Engineering Design Standard Section 5-1

ADDENDUM TO BUCKEYE GRADING AND DRAINAGE DESIGN STANDARDS

Request No. 1	APPROVED: Y / N	ADDENDUM NUMBER <u>GD1</u>
----------------------	------------------------	-----------------------------------

MODIFIED HEADWALL DETAIL

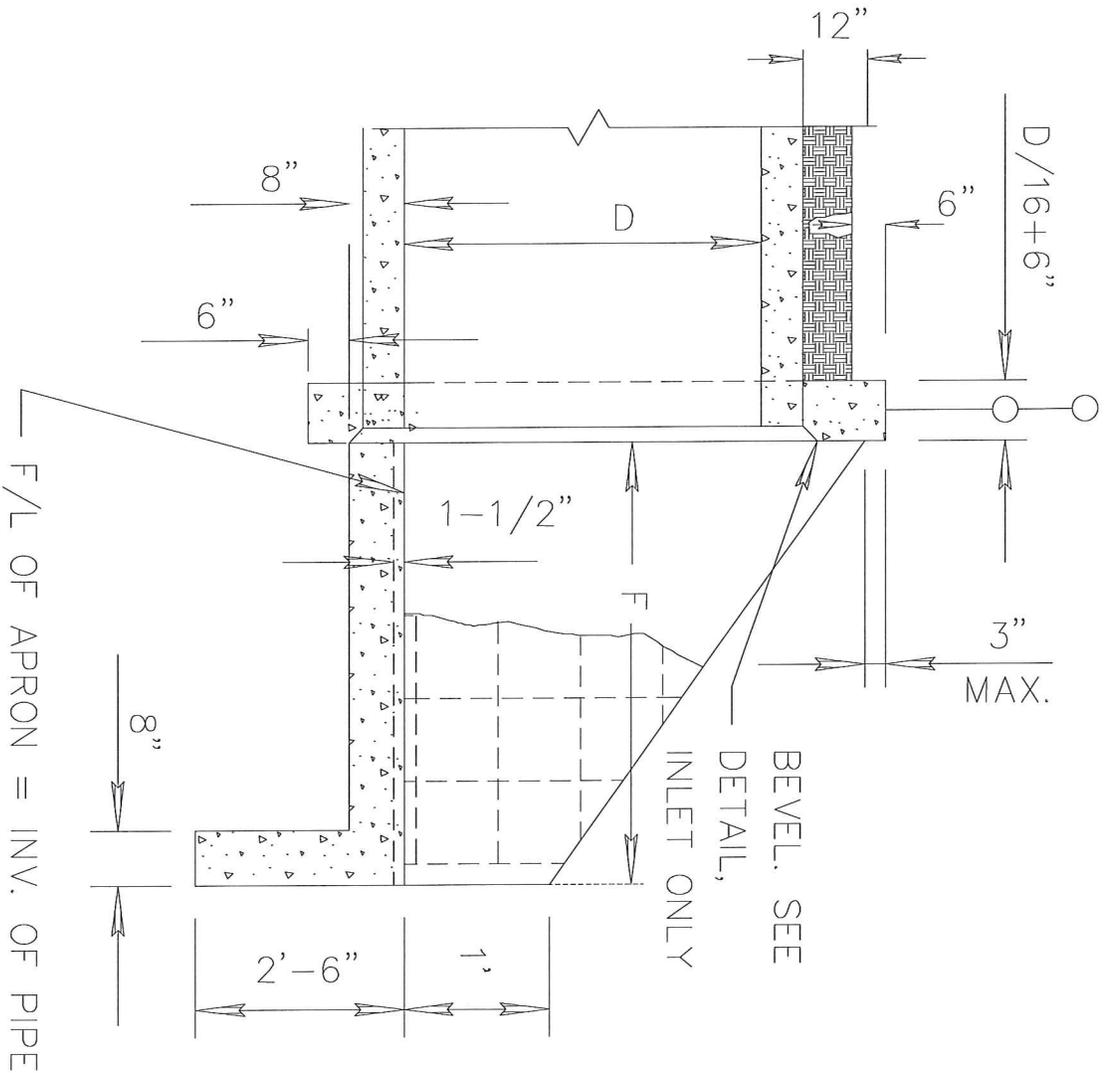
Add the City of Buckeye detail "Modified Headwall Detail" 51200.
